WATER MAIN STATION
 HOR. SCALE 1" = 20'-0"
 VER. SCALE 1" = 4'-0"

<small>540 Commercial Street, Manchester, NH 03101 (603) 668-8223 • Fax (603) 668-8502 cde@cldeengineers.com • www.cldeengineers.com Maine • New Hampshire • Vermont</small>	PROJECT NAME: RUTLAND CITY PROJECT NUMBER: BRF 3000(18)
	FILE NAME: #FILEABBREV# PROJECT LEADER: C. BEAN DESIGNED BY: D. LEWIS WATER PROFILE

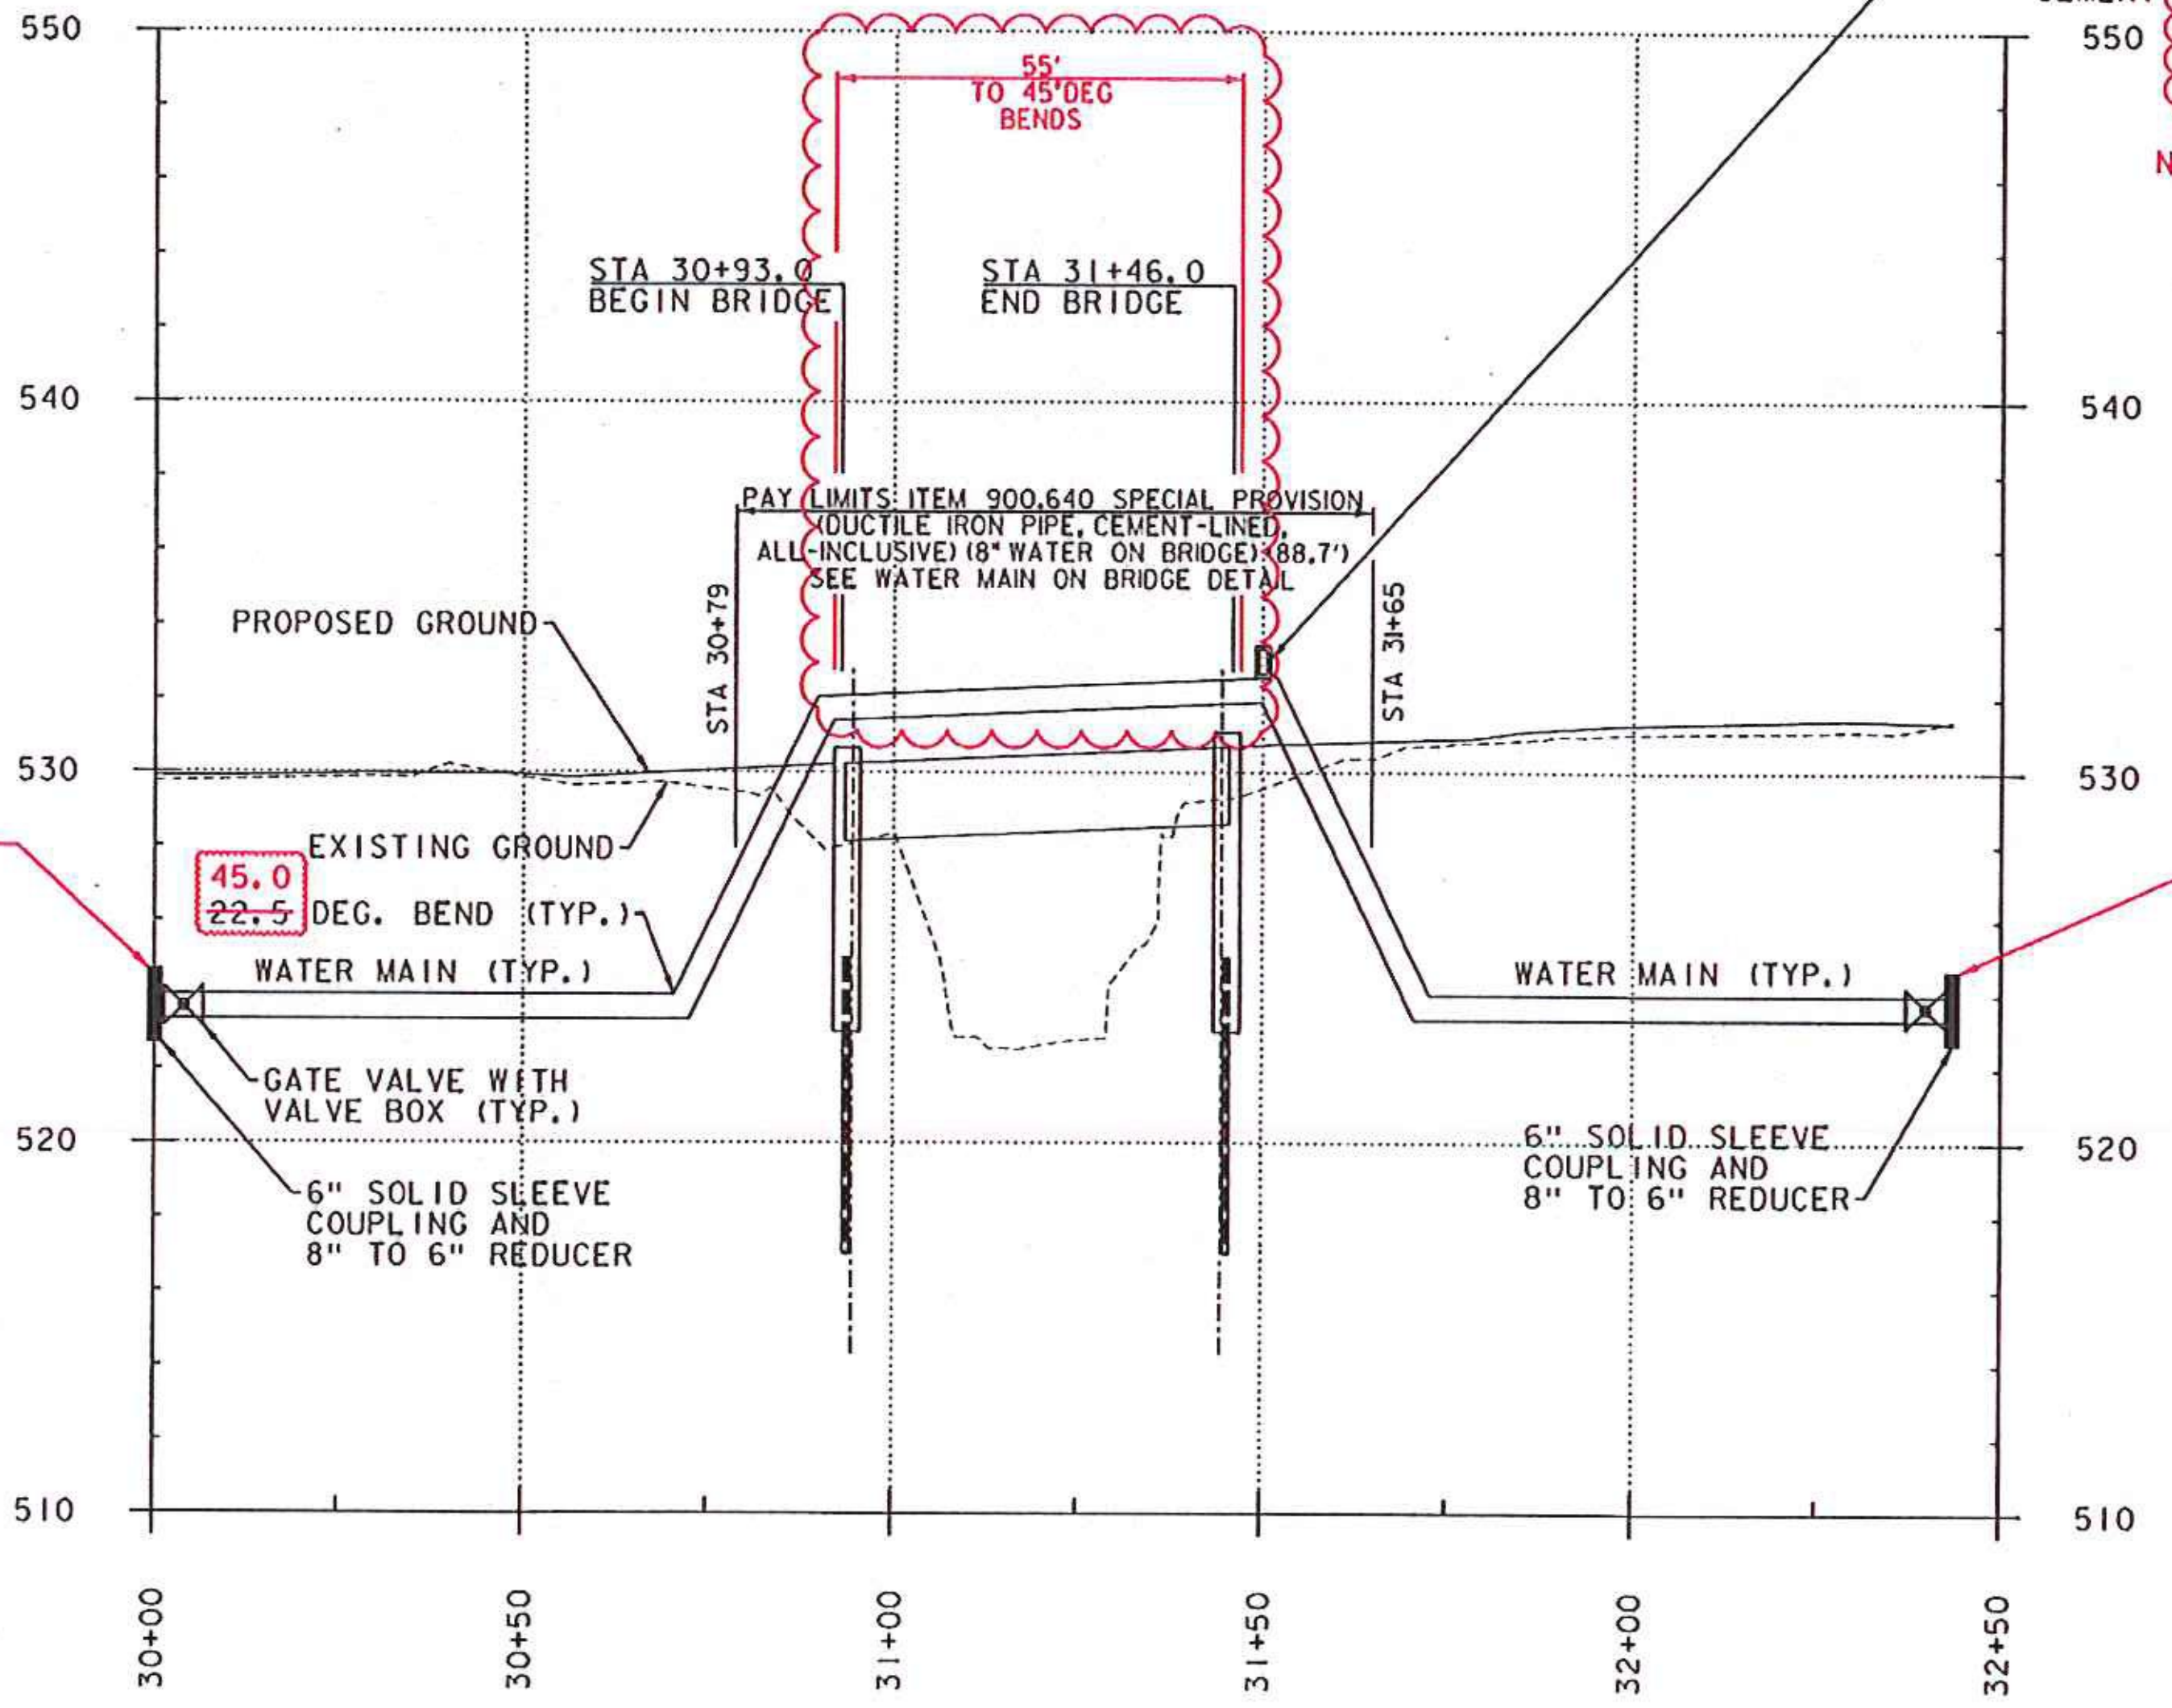
~~INSTALL AIR RELIEF VALVE WITH WEATHERPROOF, INSULATED AND LOCKABLE ENCLOSURE. PROVIDE FABRICATION DRAWING FOR REVIEW. COST SHALL BE INCIDENTAL TO ITEM 900.640 SPECIAL PROVISION (DUCTILE IRON PIPE, CEMENT-LINED, ALL-INCLUSIVE) (8" WATER ON BRIDGE)~~
 NOT REQUIRED BY CITY

- ③ RECORD CHANGES [CLOUD]
- ② PLAN REVISIONS
 3/5/14: REVISED WATER MAIN PROFILE ON BRIDGE TO ACCOMMODATE HANGER INSTALLATION REQUIREMENTS. REVISED AIR RELIEF VALVE AND GATE VALVE LOCATIONS.
- ① 1/16/14: ADDED NOTE TO DEFINE INSULATION EXTENT AND CORRECTED SCALE (PER DEC).
